# Service Update

## 18175 Incorrect Bolt for Brake Pedal Assembly

Reference Number: N182167170

Release Date: May 2018  
Revision: 00

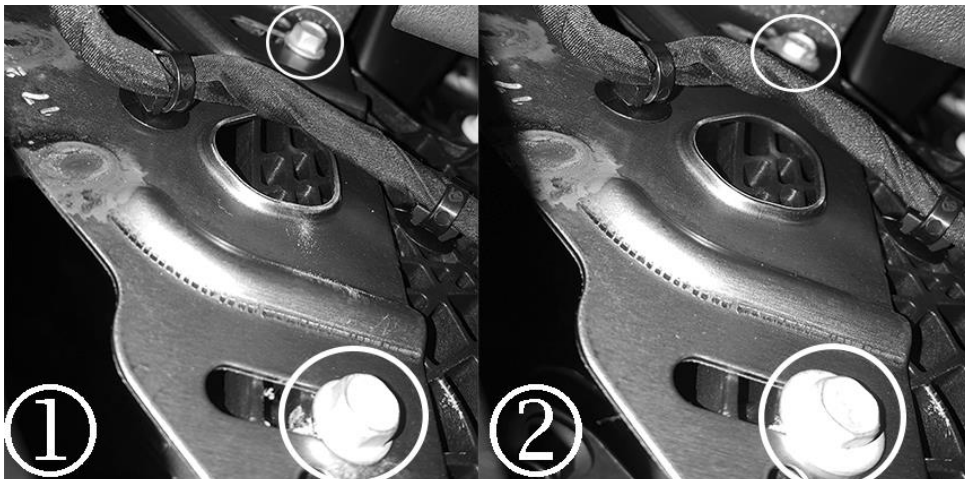
2. Inspect the two bolts shown on the brake pedal assembly. If there is no captured washer on the bolts (1), proceed to step 3. If the bolts already have a captured washer (2), proceed to step 4.
3. Replace the bolts one at a time. Torque the new bolts to 9N-m (80 Lb-in).
4. Reinstall the left side instrument panel lower trim panel insulator. Refer to *Instrument Panel Lower Trim Panel Insulator Replacement - Left Side* in SI.
